**Subject:** DA2021/1522 - 189 Riverview Road - on behalf of Ms Lenthall of 187 Riverview Road, Avalon

**Submission with regard to Development Application DA2021/1522  
Demolition works and construction of a dwelling house  
189 Riverview Road, Avalon**

Figure 1 – Extract from DA Master set plans

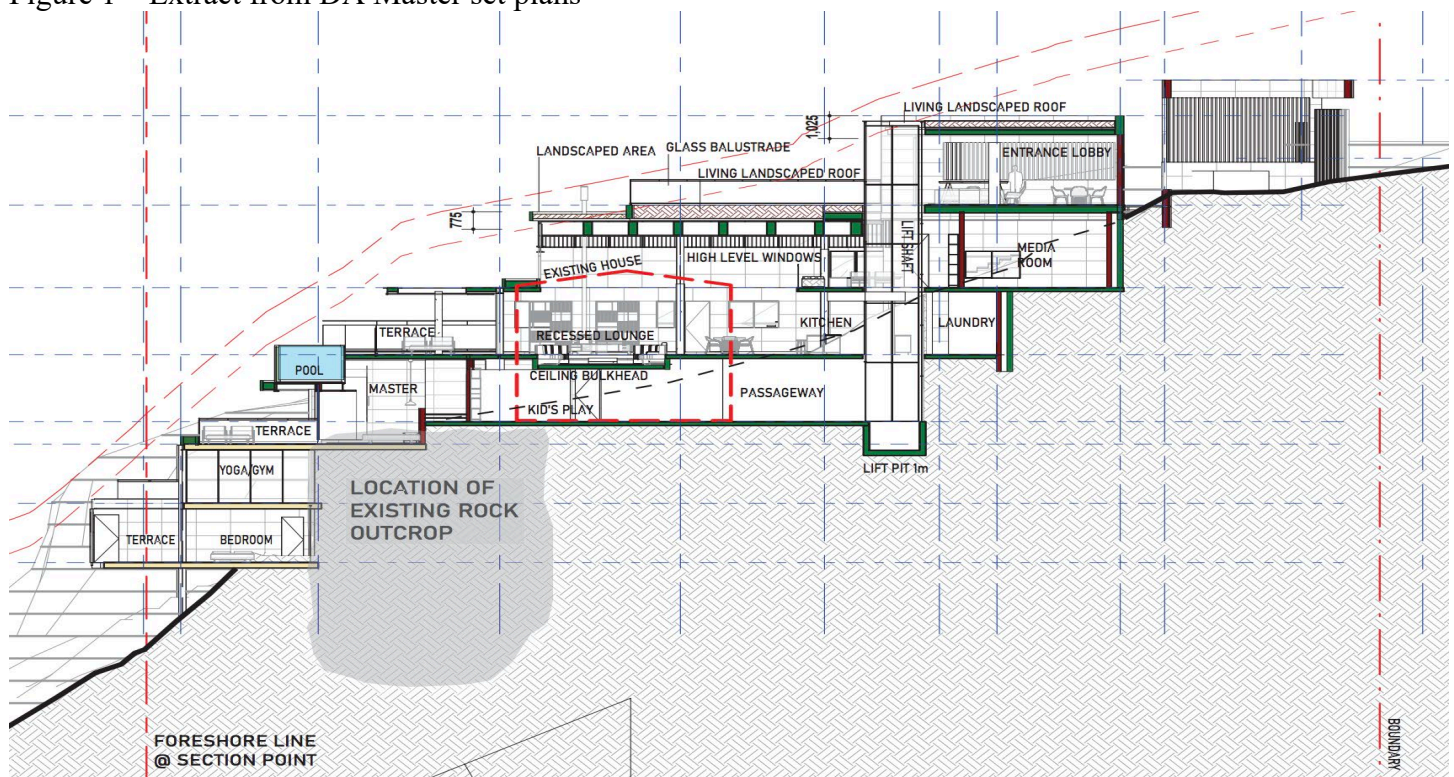
A detached older style 2 storey dwelling currently occupies the site and this is proposed to be demolished to make way for the proposed development. The scale of the proposed development compared to the existing dwelling house is shown in Figure 1 below. The impacts of the height, bulk, scale and massing of the proposed development are set out in this submission letter.

Figure 2 – Extract of building envelope at southern boundary

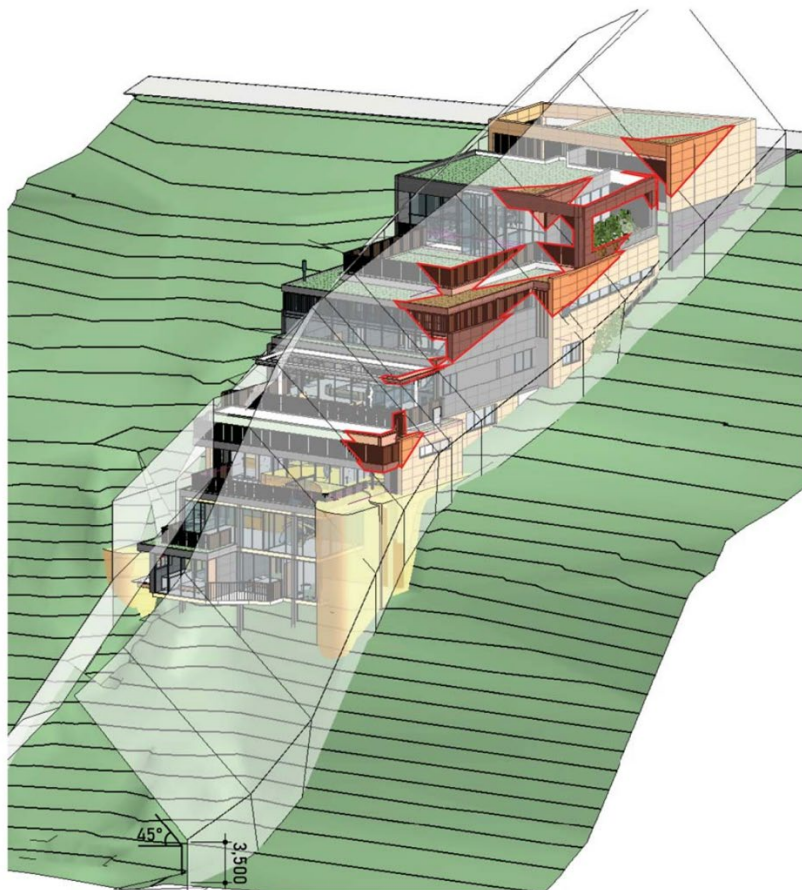
**Comment:** The Development Application does not comply with DCP Control D4.8 Building Envelope. The proposed development exceeds the building envelope control along almost the entire southern boundary of the site and results in view loss and solar access implications for my client. This is acknowledged in the SEE and justification put forward. Non-compliance on merit should not be considered given the stated impacts to arise from the proposed development on neighbouring amenity or the surrounding environment. Should the

development be set back from the southern boundary of the site, this would assist with addressing some of these concerns.
